Appendix E – Facility Reports - Buildings

City Hall - Exterior
 401 Grove Street
 Healdsburg, CA

Villa Chanticleer
 1248 North Fitch Mountain Road
 Healdsburg, CA

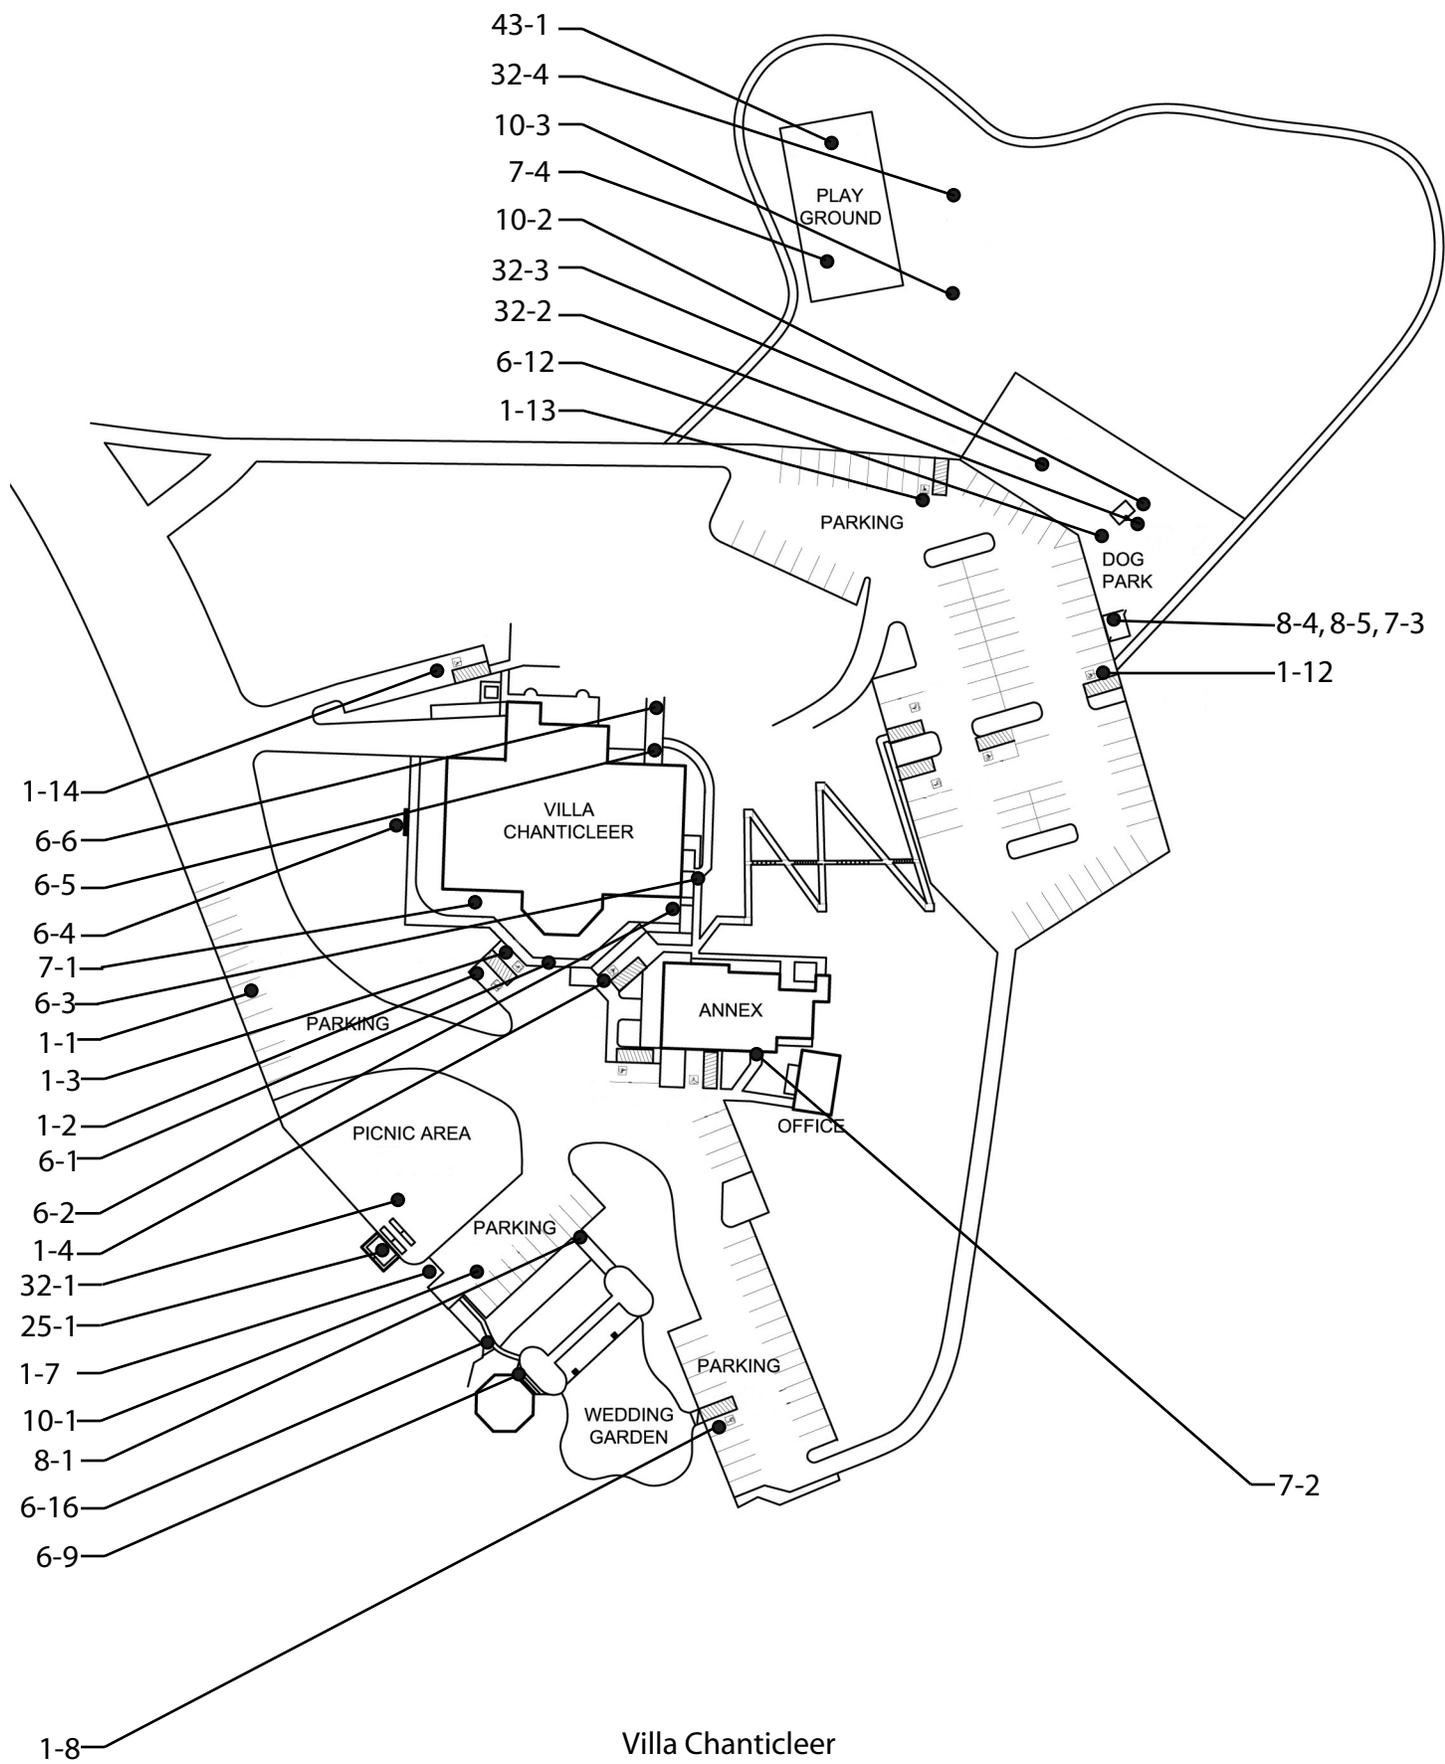
Exterior	
1 - 1	Parking Area
Priority: 1	
Provide or modify accessible spaces	\$250
Notes: There are 27 parking spaces in the entrance parking lot (including 5 parallel parking spaces). Provide an accessible parking space, 9 ft. wide by 18 ft. long-marked with the Int'l Symbol of Accessibility, closest to an accessible entry to picnic area.	
State: 1129B, 1129B.1, 1129B.4, 1129B.4 #1	
Federal: 4.1.2(5)(b), 4.6.2, 4.6.3, 4.6.4	
Install sign	\$250
Notes: Provide an additional sign at each designated space that states "Minimum Fine \$250." All post-mounted signs should be mounted 80" min. above the parking surface. Paint the words NO PARKING in the access aisle in white, 12" letters	
State: 1129B.3 #1, 1129B.3 #2, 1129B.4	
Federal: -	
Install sign for unauthorized parking	\$400
Notes: Provide a warning sign at each accessible parking space at the site or provide one sign at the entrance.	
State: 1129B.4, 1133B.8.6.3

Exterior		
1 - 2	Parking Area	Priority: 1
Install sign		\$250
Notes: Paint the words NO PARKING in the shared access aisle in white, 12" letters. Provide an additional sign at each designated space that states "Minimum Fine \$250."		
State: 1129B.3 #1, 1129B.3 #2, 1129B.4		
Federal: -		
Install van parking sign		\$250
Notes: Provide a "Van Accessible" sign at the accessible parking space.		
State: 1129B.4		
Federal: 4.6.4		
Provide or modify accessible access aisles		\$150
Notes: Provide a blue border around the shared access aisle (see also feature 1-3).		
State: 1129B.3 #2		
Federal: 4.6.3		
Install sign for unauthorized parking		\$400
Notes: Provide a warning sign at each accessible parking space at the site or provide one sign at the entrance.		
State: 1129B.4, 1133B.8.6.3		
Federal: -		
1 - 3	Parking Area	Priority: 1
Install sign		\$250
Notes: Provide an additional sign at each designated space that states "Minimum Fine \$250."

Exterior		Priority: 1
1 - 4	Parking Area	
Regrade surface		\$1,000
Notes: Slope of the parking space and access aisle exceeds 3% (2% max.).		
State: 1129B.3 #4		
Federal: 4.6.3		
Install sign		\$250
Notes: Paint the words NO PARKING in the access aisle in white, 12" letters. Provide an additional sign at each designated space that states "Minimum Fine \$250."		
State: 1129B.3 #1, 1129B.3 #2, 1129B.4		
Federal: -		
Provide or modify accessible access aisles		\$150
Notes: Access aisle width is 51" (96" min.). Provide a blue border around the access aisle.		
State: 1129B.3 #1, 1129B.3 #2, 1129B.4 #1		
Federal: 4.6.3		
Install van parking sign		\$250
Notes: Remove the requirement for an "Automatic Ramp" from the "Van Accessible" sign.		
State: 1129B.4		
Federal: 4.6.4		
Install sign for unauthorized parking		\$400
Notes: Provide a warning sign at each accessible parking space at the site or provide one sign at the entrance.

Exterior		
1 - 7	Parking Area	Priority: 1
Provide or modify accessible spaces		\$250
Notes: There are 19 parking spaces in the parking area adjacent to the entrance at the lower level of the Wedding Garden. Provide an accessible parking space, 9 ft. wide by 18 ft. long, closest to an accessible entry to the lower level of the Wedding Garden.		
State: 1129B, 1129B.1, 1129B.4, 1129B.4 #1		
Federal: 4.1.2(5)(b), 4.6.2, 4.6.3, 4.6.4		
Install sign		\$250
Notes: Provide an additional sign at each designated space that states "Minimum Fine \$250." All post-mounted signs should be mounted 80" min. above the parking surface. Paint the words NO PARKING in the access aisle in white, 12" letters		
State: 1129B.3 #1, 1129B.3 #2, 1129B.4		
Federal: -		
Install sign for unauthorized parking		\$400
Notes: Provide a warning sign at each accessible parking space at the site or provide one sign at the entrance.		
State: 1129B.4, 1133B.8.6.3

Exterior		
6 - 3	Stairway	Priority:2
Install or modify handrails		\$3,600
Notes: Handrails are 3.5" (1.5") from the wall. Wall next to handrails are also abrasive. There are 6 risers.		
State: 1133B.4.2.5, 1133B.4.2.6		
Federal: 4.26.4, 4.9.4 #3		
Replace stairs		\$2,250
Notes: Some risers are 8" (4" to 7") high. Bottom tread is cracked. There are 6 risers.		
State: 1009.3		
Federal: -		
6 - 4	Stairway	Priority:2
Install tread striping		\$45
Notes: Indicator stripes are not provided. There are 3 risers.		
State: 1127B.4, 1133B.4.4		
Federal: -		
Install or modify handrails		\$2,400
Notes: Handrails top surface mounted 40" to 44" (34" to 38") AFF. There are 3 risers.		
State: 1133B.4.2.1		
Federal: 4.9.4 #5		
Repair stair nosings		\$0
Notes: Underside of nosing overhangs and creates a tripping hazard. There are 3 risers.		
State: 1133B.4.5.3		
Federal: 4.9.3		
Replace stairs		\$1,125
Notes: Some risers are 8" (4" to 7") high. There are 3 risers.

Exterior		
7 - 2	Hazard	Priority:2
Install warning curb or remove drop-off		\$500
Notes: There is a 7" drop-off at the accessible entrance to the Annex. Provide a guardrail or a 6" high warning curb.		
State: 1133B.8.1		
Federal: -		
7 - 3	Hazard	Priority:2
Remove overhanging or protruding objects		\$100
Notes: The lower edge of the doggie bag dispenser is 43" above the ground and protrudes 7" (4" max.) into the gated enclosure.		
State: 1133B.8.6.1		
Federal: 4.4.1		
7 - 4	Hazard	Priority:2
Install warning curb or remove drop-off		\$1,000
Notes: There is a 6-1/2" drop-off from the path to play area surfacing. Provide additional surfacing to reduce drop-off to 4" max.		
State: 1133B.8.1		
Federal: -		
8 - 1	Door/Gate	Priority:2
Increase or provide maneuvering or clear floor area		\$2,500
Notes: Villa Garden: Slope on the swing-side of the gate is 9.7% (2% max). Regrade slope to not exceed 2% in any direction. Surface is asphalt.

Exterior		
10 - 1	Drinking Fountain	Priority: 3
Provide an accessible path of travel		\$10,000
Notes: Provide an accessible route to the drinking fountain.		
State: 1114B.1.2, 1115B.4.6		
Federal: 4.3.2		
Increase or provide maneuvering or clear floor area		\$2,500
Notes: Clear space in front of drinking fountain is inadequate (30" x 48" min.).		
State: 1115B.4.6 #2		
Federal: 4.15.5		
Replace or reposition drinking fountain		\$3,500
Notes: Replace DF w/hi-lo fountain (with the "hi" bubbler located at 36" max.) and provide adequate clear ground space.		
State: 1115B.4.6 #1, 1115B.4.6 #4		
Federal: 4.1.6, 4.15.2		
Replace or adjust water controls		\$500
Notes: Controls require twisting and grasping to operate.		
State: 1115B.4.6 #4		
Federal: 4.15.4		
10 - 2	Drinking Fountain	Priority: 3
Provide an accessible path of travel		\$10,000
Notes: Provide an accessible route to the drinking fountain.		
State: 1114B.1.2, 1115B.4.6

Exterior		
32 - 1	Picnic Area	Priority: 2
Provide an accessible path of travel		\$10,000
Notes: Provide an accessible route to the picnic area.		
State: 1132B.2 #2		
Federal: -		
Provide an accessible table		\$1,000
Notes: There are no fixed picnic tables. None of the 32 tables in this area has a wheelchair seating space (the knee space under a typical table is 14" deep and 19" deep is required).		
State: 1132B.3.1 #2		
Federal: 306.3		
Provide a firm, stable and slip resistant surface		\$1,000
Notes: In general, the picnic area surface is not stable.		
State: -		
Federal: 306.3		
Replace or reposition picnic grill		\$800
Notes: The cooking surface of the grill is 35" above the ground (34" max.).		
State: -		
Federal: 308		
Modify operating mechanism		\$500
Notes: Controls on the grill require twisting and grasping to operate and are located at 62" above the ground (48" max. for front reach and 54" max. for side reach).

Villa Chanticleer - First Floor
 1248 North Fitch Mountain Road
 Healdsburg, CA

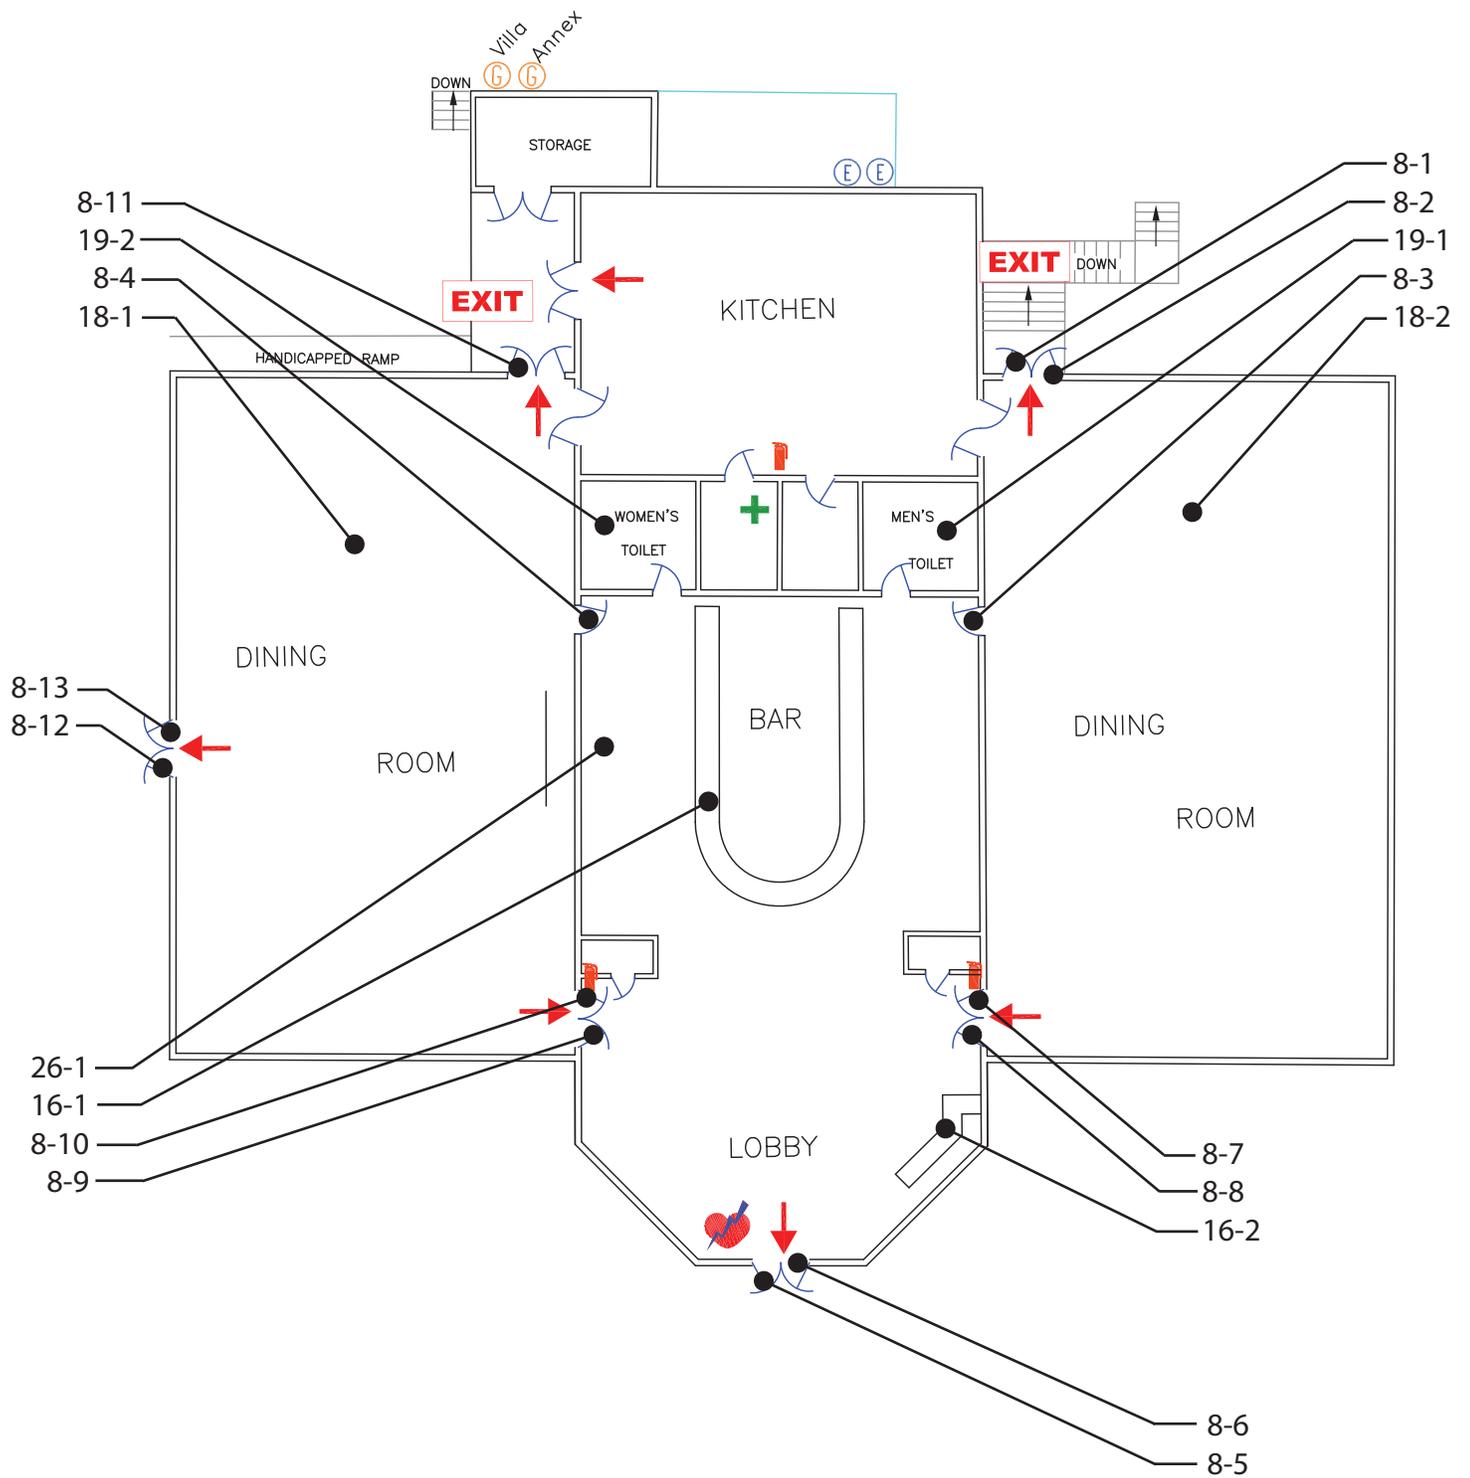
Floor 1		
8 - 1	Door/Gate	Priority: 1
Adjust door closer		\$100
Notes: Operating effort is 10 lbs (5 lbs max).		
State: 1133B.2.5		
Federal: 4.13.11		
Install or modify permanent room signs		\$250
Notes: There is an illuminated exit sign but tactile sign is not provided.		
State: 1011.3 #3		
Federal: -		
8 - 2	Door/Gate	Priority: 1
Adjust door closer		\$100
Notes: Operating effort is 8 lbs (5 lbs max).		
State: 1133B.2.5		
Federal: 4.13.11		
8 - 3	Door/Gate	Priority: 2
Adjust door closer		\$100
Notes: Operating effort is 7 lbs (5 lbs max).		
State: 1133B.2.5		
Federal: 4.13.11		
Provide additional strike edge clearance		\$3,000
Notes: Strike-edge clearance on the swing-side of the door is 13" (18" min).		
State: 1133B.2.4.3		
Federal: 4.13.6		
8 - 4	Door/Gate	Priority: 2
Adjust door closer		\$100
Notes: Operating effort is 6.5 lbs (5 lbs max).		
State: 1133B.2.5		
Federal: 4.13.11		
Provide additional strike edge clearance		\$3,000

Floor 1		
8 - 5	Door/Gate	Priority:2
Adjust door closer		\$100
Notes: Operating effort is 6 lbs (5 lbs max).		
State: 1133B.2.5		
Federal: 4.13.11		
Provide sign(s) indicating accessible entries and facilities		\$250
Notes: Accessible entry is not marked with the International Symbol of Accessibility.		
State: 1117B.5.8.1.2, 1127B.3		
Federal: 4.13.6		
Install or modify permanent room signs		\$250
Notes: There is an illuminated exit sign but tactile sign is not provided.		
State: 1011.3 #3		
Federal: -		
8 - 6	Door/Gate	Priority:2
Adjust door closer		\$100
Notes: Operating effort is 12 lbs (5 lbs max).		
State: 1133B.2.5		
Federal: 4.13.11		
8 - 7	Door/Gate	Priority:2
Adjust door closer		\$100
Notes: Operating effort is 7 lbs (5 lbs max).		
State: 1133B.2.5		
Federal: 4.13.11		
8 - 8	Door/Gate	Priority:2
Adjust door closer		\$100
Notes: Operating effort is 9 lbs (5 lbs max).		
State: 1133B.2.5		
Federal: 4.13.11		
8 - 9	Door/Gate	Priority:2

Federal: 4.32.4		
16 - 2	Transaction Counter	Priority:2
Provide an accessible counter		\$4,000
Notes: Check-in counter is 43.5" (34" max) AFF.		
State: 1122B.5		
Federal: 4.32.4

Floor 1		
18 - 1	Room	Priority:2
Remove overhanging or protruding objects		\$1,200
Notes: In the west-side dining room, there are 12 wall sconce that create protruding hazards. Each wall sconce protrudes 8" (4" max) and is 70" (not between 27" to 80") AFF.		
State: 1133B.8.6.1		
Federal: 4.4.1		
18 - 2	Room	Priority:2
Remove overhanging or protruding objects		\$1,300
Notes: In the east-side dining room, there are 13 wall sconce that create protruding hazards. Each wall sconce protrudes 8" (4" max) and is 70" (not between 27" to 80") AFF.		
State: 1133B.8.6.1		
Federal: 4.4.1		
19 - 1	Multiple User Restroom	Priority:2
Install sign		\$250
Notes: California required sign is not provided on the door.		
State: 1115B.6		
Federal: 4.30.4		
Install sign		\$250
Notes: Federal required sign is not provided on the door.		
State: 1115B.6, 1117B.5.1 #1		
Federal: 4.30.4		
Provide or replace stall door hardware		\$100
Notes: U-shape handle not provided on the back of the compartment door.

Floor 1		
19 - 2	Multiple User Restroom	Priority:2
Install sign		\$250
Notes: California required sign is not provided on the door.		
State: 1115B.6		
Federal: 4.30.4		
Install sign		\$250
Notes: Federal required sign is not provided on the door.		
State: 1115B.6, 1117B.5.1 #1		
Federal: 4.30.4		
Provide or replace stall door hardware		\$200
Notes: U-shape handle not provided on the front or back of the compartment door.		
State: 1115B.3.1 #4.5		
Federal: 4.13.9		
Replace or reposition dispensers or mirrors		\$100
Notes: Seat cover dispenser is mounted 41" (40" max) AFF.		
State: 1115B.8.3		
Federal: 4.23.7		
Modify stall partitions and doors		\$500
Notes: For end-entry compartment, clear floor space is 51" (60" min).		
State: -		
Federal: 4.17.3		
26 - 1	Eating Area	Priority:2
Provide an accessible table		\$1,000
Notes: There are 8 booths located in the bar area. Knee space width is 26" (30" min). Modify one table for accessibility.
